Access Compliance Report

Public Rights-of-Way

Intersection ID: 4249	Main Street: N_TRYON_ST	Cross Street: PAVILION_BV	Location: SE
ADA ID: 5B35FA675BBE	Ramp Type: Perp	Initial Pass/Fail: Fail	Overall Compliance: No
		Severity Score: 1.25

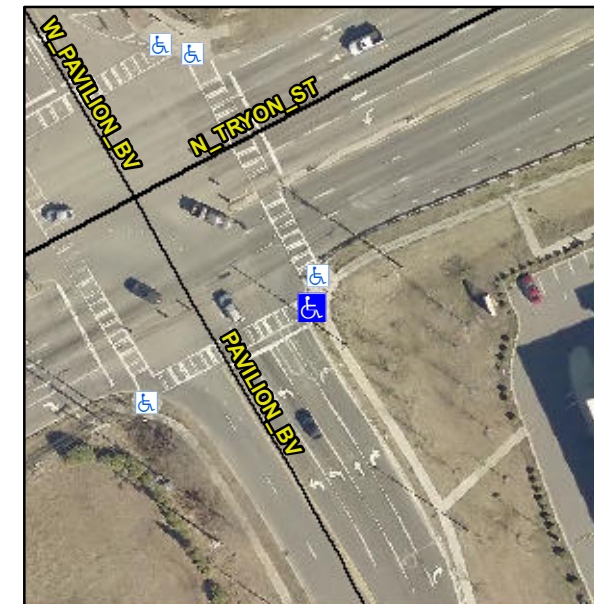
Not Found, R304.5.3

Compliance	Description	Data	Compliance	Description	Data
N/A	Ramp Length (in)	78.0	Yes	Ramp Slope (%)	5.6
Yes	Ramp Width (in)	49.0	No	Ramp XSlope (%)	3.8
N/A	Flare Type LT	N/A	N/A	Flare Type RT	N/A
N/A	Flare Slope LT (%)	N/A	N/A	Flare Slope RT (%)	N/A
N/A	Flare Traversable LT?	N/A	N/A	Flare Traversable RT?	N/A
N/A	Landing Length (in)	N/A	N/A	DWS Provided?	N/A
N/A	Landing Width (in)	N/A	N/A	DWS Contrast?	N/A
N/A	Landing Slope (%)	N/A	N/A	DWS Length (in)	N/A
N/A	Landing X Slope (%)	N/A	N/A	DWS Full Width?	N/A
N/A	Landing Curb? (Y/N)	N/A	N/A	DWS Offset (in)	N/A
N/A	Shared Landing?	N/A			
N/A	Gutter Ponding?	N/A	N/A	Gutter Slope (%)	N/A
N/A	Gutter Lip Ht (in)	N/A	N/A	Gutter X Slope (%)	N/A
N/A	Painted X Walk1?	Yes	N/A	Painted X Walk2?	N/A
	X Walk 1 Direction	To SW		X Walk 2 Direction	N/A
N/A	X Walk 1 Width (in)	100.0	N/A	X Walk 2 Width (in)	N/A
	X Walk 1 Slope (%)	0.6		X Walk 2 Slope (%)	N/A
	X Walk 1 X Slope (%)	1.5		X Walk 2 X Slope (%)	N/A

Remove & Replace Entire Ramp.
